The Commission has issued the enclosed Amendments Nos. 30 and 29 to Facility Operating Licenses Nos. DPR-32 and DPR-37 for the Surry Power Station, Units Nos. 1 and 2, respectively. These amendments consist of changes to the Technical Specifications for each license in response to your application dated September 27, 1976, as supplemented October 29, 1976, and as discussed with your staff on January 13 and March 4, 1977.

These amendments relate to revised enthalpy rise hot channel factor (FAH) Technical Specifications for Surry Units Nos. 1 and 2 to account for new fuel rod bow information.

AMENDMENT TO FACILITY OPERATING LICENSE

SAFETY EVALUATION BY THE OFFICE OF NUCLEAR REACTOR REGULATION

REGION AVERAGE BURNUP (1000 MWD/KTU)
FIGURE 3.12-9 INTERIM THIMBLE CELL ROD BURNUP ON $\frac{M}{M}$
SURVEY UNITS NO. 1 AND 2

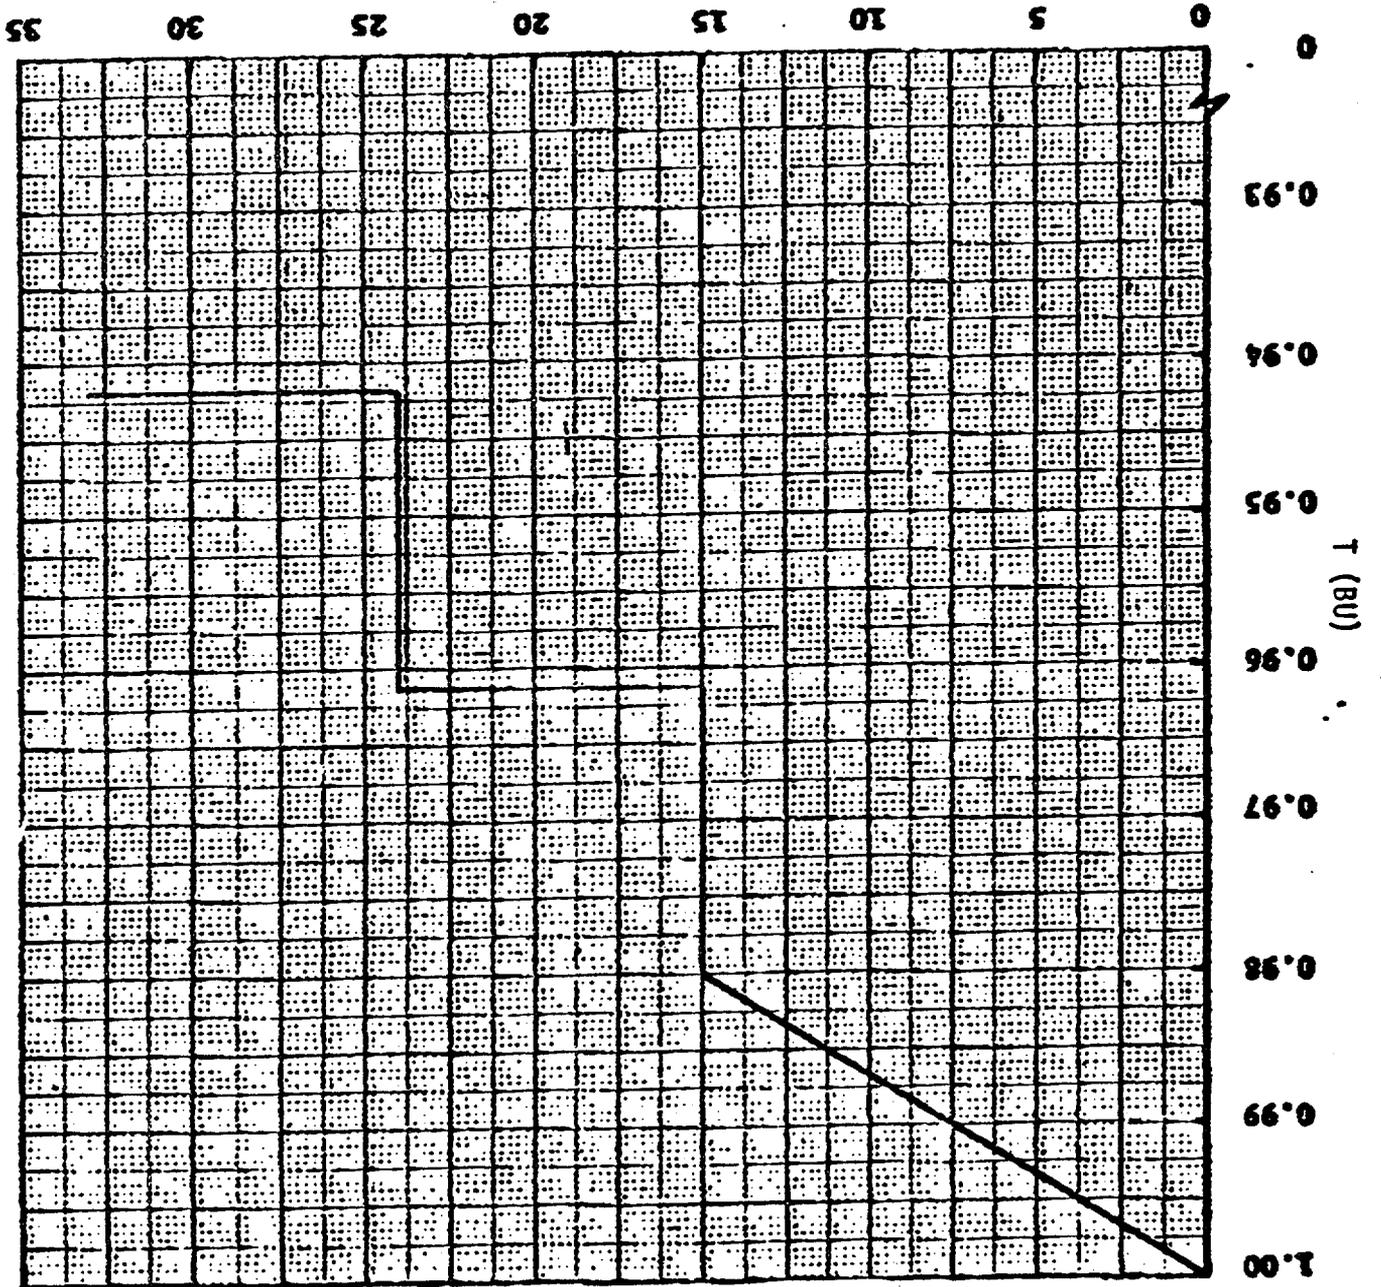
where P is the fraction of rated power at which the core is operating, K(Z) is the function given in Figure 3.12-8, Z is the core height location of F_Q, and T(BU) is the interim thimble cell rod bow penalty on F_{ΔH}^N given in TS Figure 3.12-9.

A recent evaluation of DNB test data from experiments of fuel rod bowing in thimble cells has identified that it is appropriate to impose a penalty factor to the accident analyses DNBR results. This evaluation has not been completed, but in order to assure that this effect is accommodated in a conservative manner, an interim thimble cell rod bow penalty for 15 x 15 fuel, T(BU), is applied to the measured values of the enthalpy rise hot channel factor, F_{AN}^N . It is anticipated that the values of this penalty will change after the evaluation of the test data has been completed.

$$F_{\Delta H}^N \leq 1.55 (1 + 0.2(1 - P)) \times T(\text{BU})$$

FIGURE 3.12-9 INTERIM THIMBLE CELL ROD BURNUP PATTERN ON SURRY UNITS NO. 1 AND 2
REGION AVERAGE BURNUP (1000 MWD/KTU)

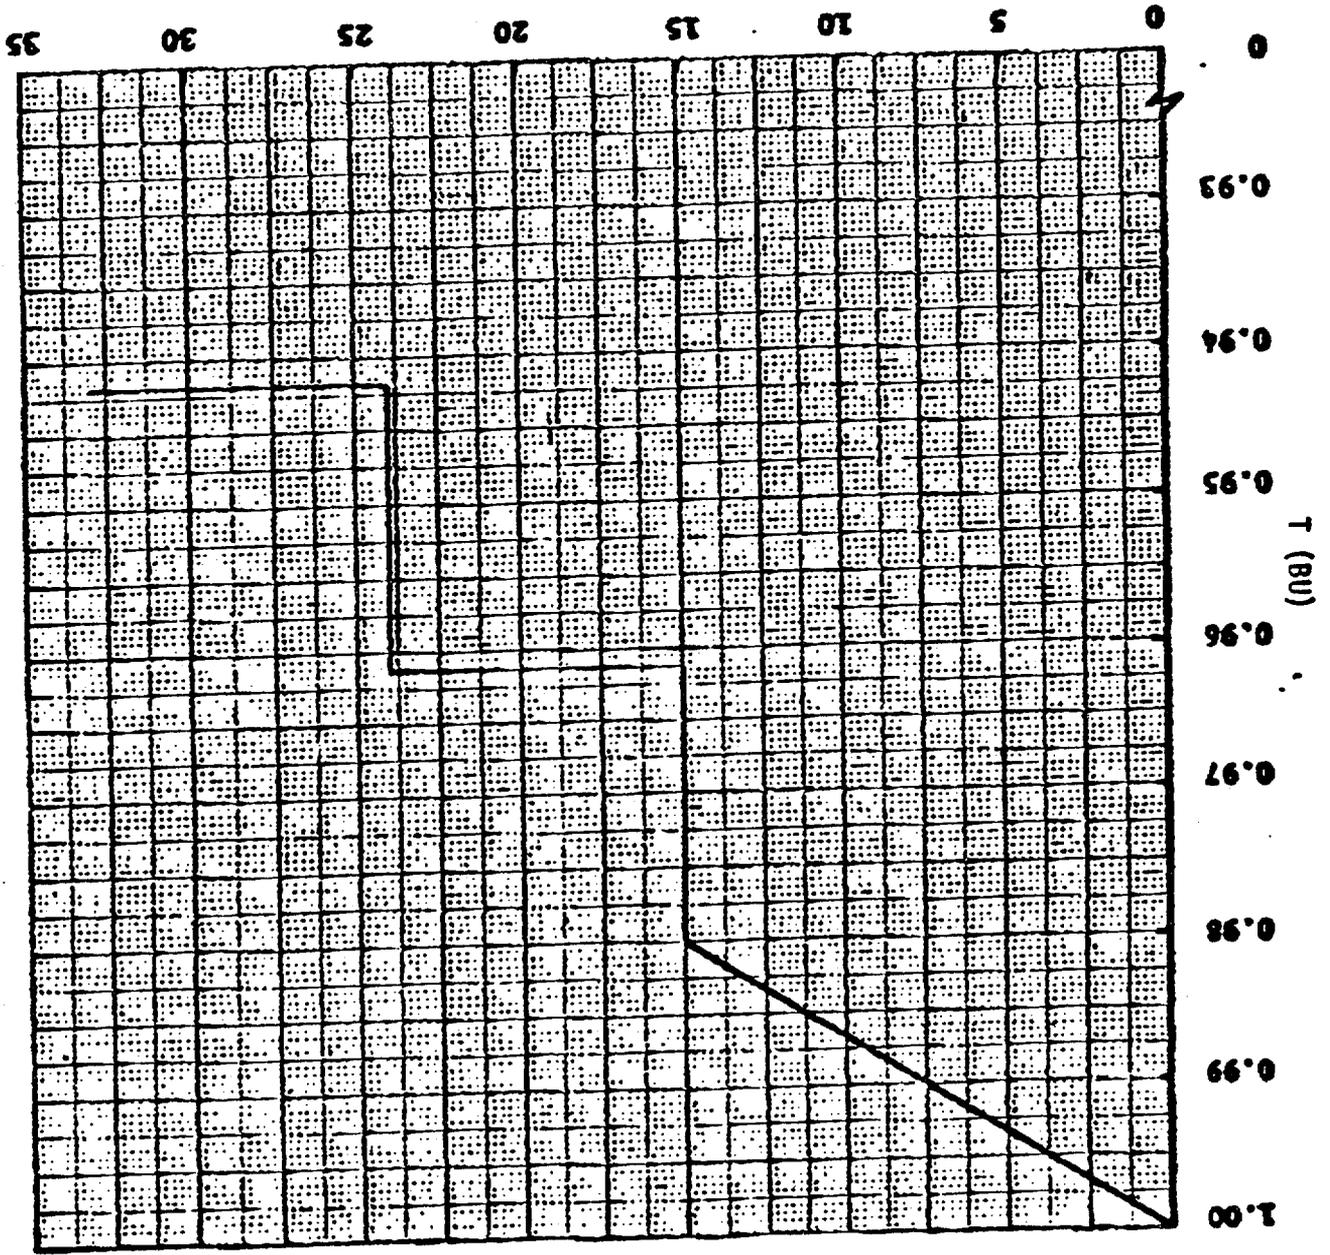
where P is the fraction of rated power at which the core is operating, K(Z) is the function given in Figure 3.12-8, Z is the core height location of F_Q , and T(BU) is the interim thimble cell rod bow penalty on $F_{\Delta H}^N$ given in TS Figure 3.12-9.

A recent evaluation of DNB test data from experiments of fuel rod bowing in thimble cells has identified that it is appropriate to impose a penalty factor to the accident analyses DNBR results. This evaluation has not been completed, but in order to assure that this effect is accommodated in a conservative manner, an interim thimble cell rod bow penalty for 15 x 15 fuel, T(BU), is applied to the measured values of the enthalpy rise hot channel factor, F_{AN}^N . It is anticipated that the values of this penalty will change after the evaluation of the test data has been completed.

$$F_{\Delta H}^N \leq 1.55 (1 + 0.2(1 - P)) \times T(\text{BU})$$

FIGURE 2.1

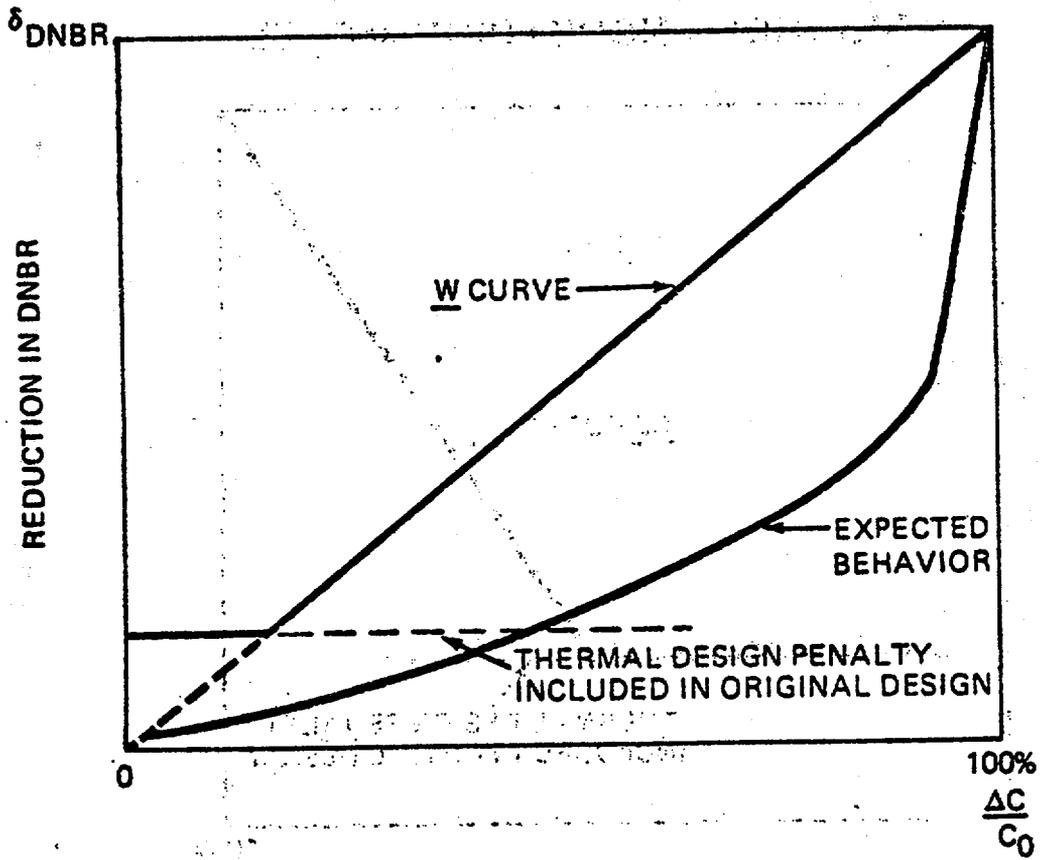
As stated in Section 2.1, data were presented by Westinghouse for the DNBR reduction at full contact and with no bow. No data at partial gap closure were presented. Westinghouse proposed, and the staff accepted, a straight line interpolation between these two points as shown in Figure 2.1.

This approach is conservative if the DNBR reduction does not increase more rapidly than the straight line reduction shown in Figure 2.1. Although the data for DNBR reduction due to rod bowing in the presence of an unheated fuel rod cannot be predicted by existing analytical methods, one would nevertheless expect that the actual behavior would more nearly follow the curved line also shown in Figure 2.1. According to this curved line, the DNBR would be reduced gradually for small amounts of bow. As the fuel rods (or fuel rod and unheated rod) become close enough so that there is an interaction, the DNBR would decrease more rapidly. No physical mechanism has been postulated which would lead to sudden large decreases in the DNBR for small or moderate gap closures. Thus, the straight line approximation is believed to be an overestimate of the expected behavior.

In developing the interim rod bow penalties described in this report, it became apparent that the penalty should be a function of burnup since the magnitude of rod bow is a function of burnup. However, to maintain existing thermal margins early in core life when only a small amount of fuel rod bow is anticipated, the initial pitch reduction factor was included until such time as the rod bow DNBR reduction became greater. This is represented as the straight horizontal line on Figure 2.1.

FIGURE 2.2

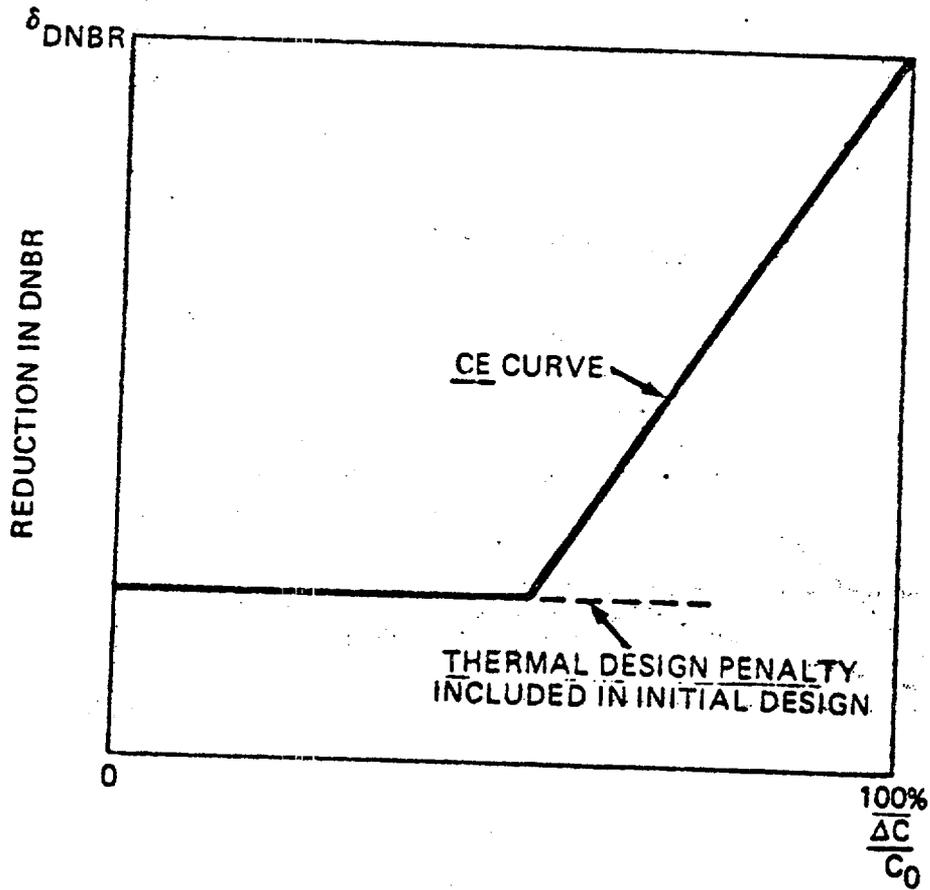
Combustion Engineering performed experiments to determine the effect of rod bowing on DNBR which included some cases in which the effect of partial bowing as well as bowing to contact was determined. Again, a straight line interpolation is used. However, the point of zero DNBR reduction is not at zero clearance reduction but rather, at an intermediate value of clearance reduction. This is shown schematically

in Figure 2.2. The horizontal straight line, representing the initial pitch reduction factor is included as explained previously in Section 2.2
